**23/01338/OUM**

Outline planning application for the erection of up to 83 Affordable Homes with associated access, parking and landscaping - all matters reserved except for means of access

**TITLE: 23/01338/OUM**

**Proposal: Outline planning application for the erection of up to 83 Affordable Homes with associated access, parking, and landscaping - all matters reserved except for means of access**

Figure 3.3 – Site Access – Proposed T-Junction

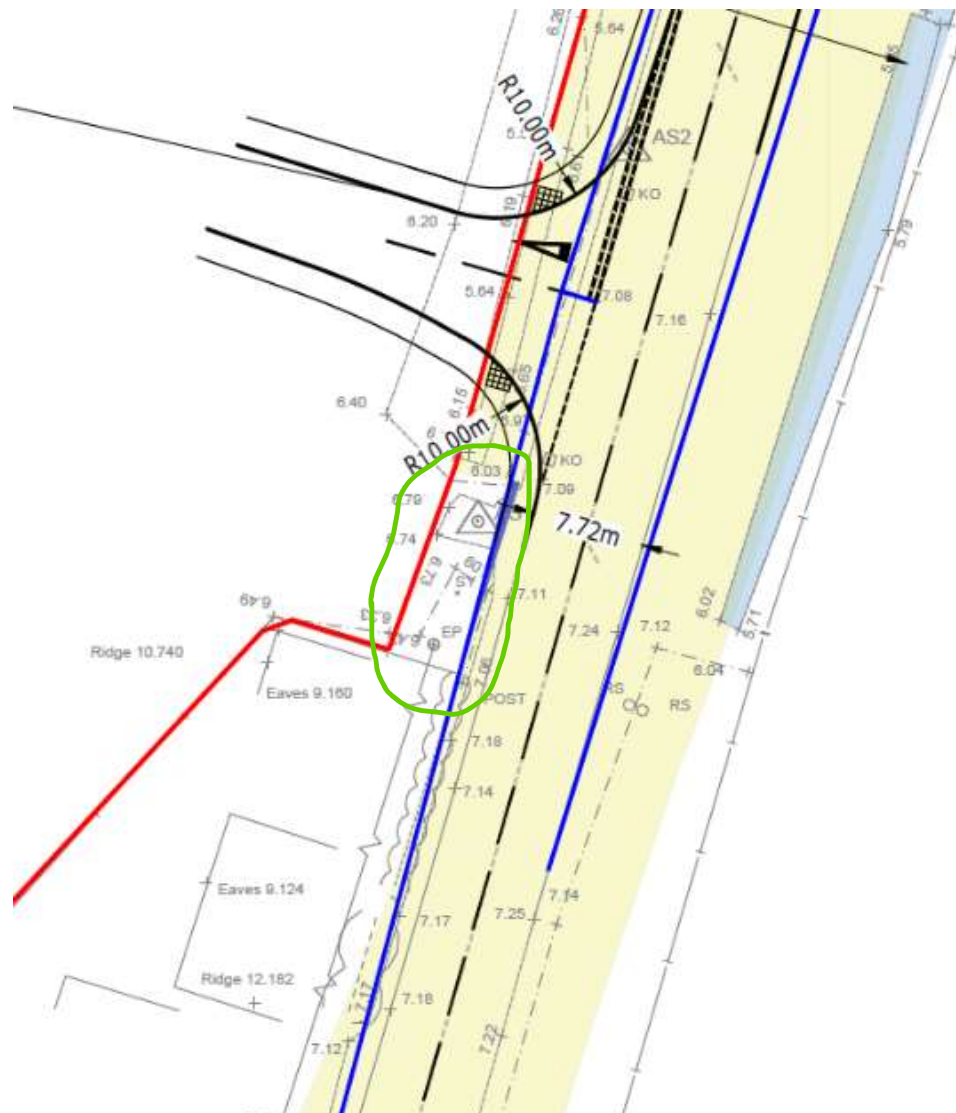
- 3.2.7 Stantec questions whether the 120m visibility splay can be achieved to the right of the proposed site access. The splay is obstructed by further existing vegetation intruding into the highway - as shown in **Figure 3.2** - as well as third-party land. The photo in Figure 3.2 has also been taken 2.4m back from the main carriageway kerbline to mimic the position of a driver waiting to turn.

- 3.2.8 Whilst Stantec accepts vegetation within the highway may be removed to increase visibility, the site access drawing (2006310-004 Rev B – Proposed Site Access Arrangements – Priority 'T' Junction) does not provide sufficient detail to confirm that the right visibility splay can be provided without potentially needing third-party land, as well as the construction of the footway kerb line (adopted public highway been shown as shaded yellow). The area of land in question is circled green below in **Figure 3.3**, and does not appear to be within public highway or the development red line boundary.

- 3.2.9 Stantec recommends the Applicant is required to provide further detail of the highway boundary for review to determine whether an appropriate visibility can be achieved without third party land.
- 3.2.10 Stantec also recommend that the existing street lighting is extended past the proposed site access, as part of the detailed design process.

Figure 3.4 – Google Maps Typical Traffic Conditions

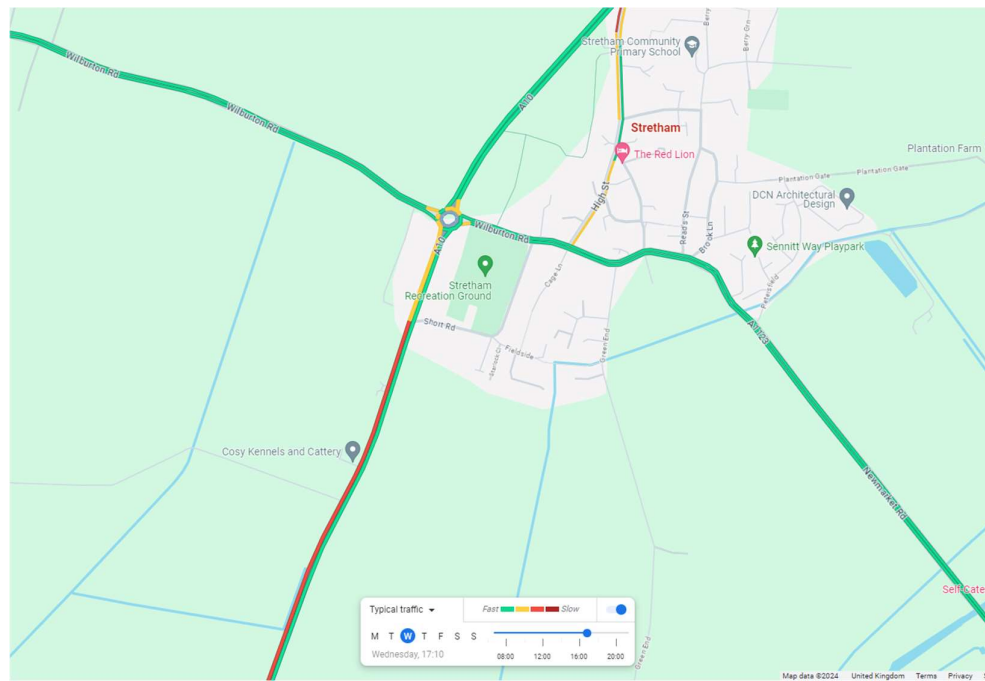
- 3.3.10 The CCC Highways Officer response referred to the A10 / A1123 roundabout peak period congestion leading to queueing traffic on the A10 extending to the proposed site access which could prevent vehicles from exiting / entering the site.
- 3.3.11 The Google Maps typical PM Peak traffic conditions shown in Figure 3.4 shows this.

3.3.12 As conditions at the A10 / A1123 Roundabout were not assessed as part of this Transport Assessment, Stantec is unable to comment further.
